SB-10056114-6520

Front Windshield Washer Jets Not Working

F56 (Cooper, Cooper S)

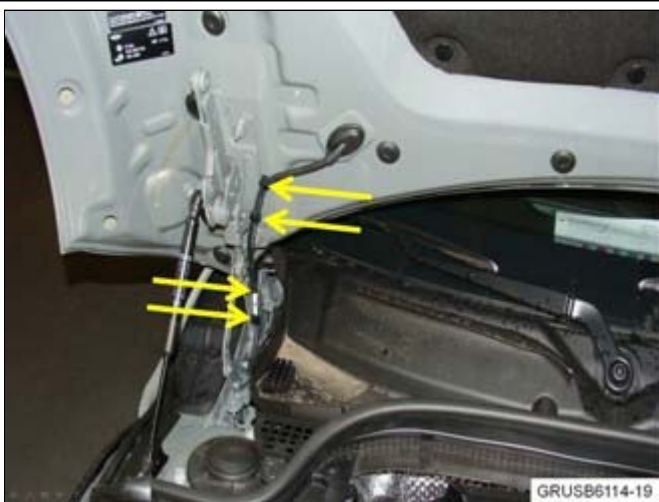
The windshield washer hose shown below is too short. This causes it to kink or disconnect.

Replace the front windshield washer hose with a new longer version.
